Subject: ADDENDUM TO WORK PLAN TO COMPLETE A DETAILED UTILITY

SURVEY AND SAMPLING, AND SOIL AND GROUNDWATER

INVESTIGATION TO ADDRESS DATA GAPS, OWENS-BROCKWAY

GLASS CONTAINER FACILITY, OAKLAND, CALIFORNIA.

Plate $2 - Revised Proposed Geoprobe^{TM} Location Map$

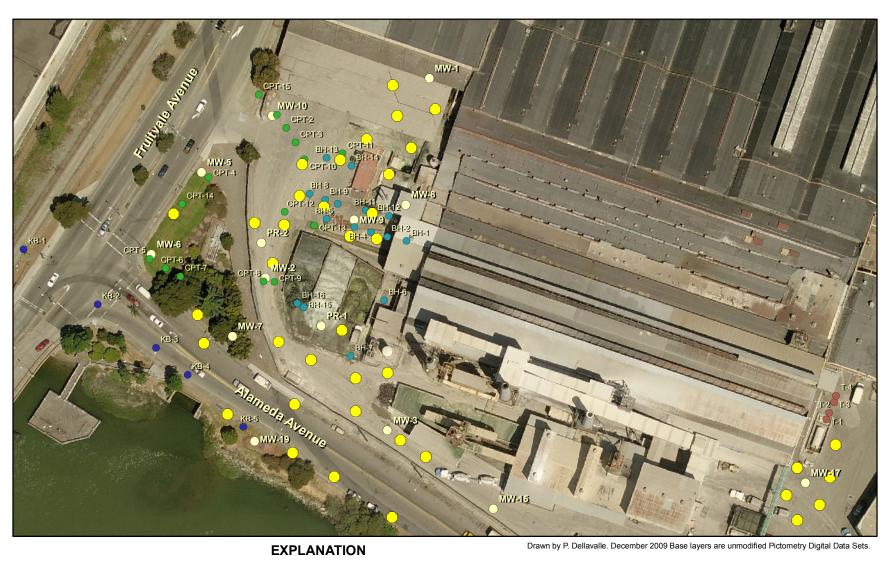
2. GeoprobeTM **Investigation** – "In Task 3 CKG proposes to install up to 45 borings...Please clarify whether thirty-six or thirty-eight locations should be illustrated...Please include a revised figure that illustrates...but also the existing monitoring well network..."

CKG has revised Plate 2 to include all previous investigation points, including monitoring wells, and to include 38 proposed GeoprobeTM locations. CKG would like to emphasize however, that the locations shown on the Plate are not to be considered absolute. Underground utilities at the site are extensive and complex. In addition the site is an active glass bottle manufacturing facility

with busy truck traffic and physical changes that occur on a daily basis. CKG will select locations in the field to the best of our ability to address the data gap areas, but the safety of personnel and the need to protect on site equipment are paramount. CKG also will modify sampling locations based on observations made during the investigation. This is why there are 38 sample locations shown but a total of 45 locations are planned. The seven "reserve" locations will be used to provide additional assessment as needed.
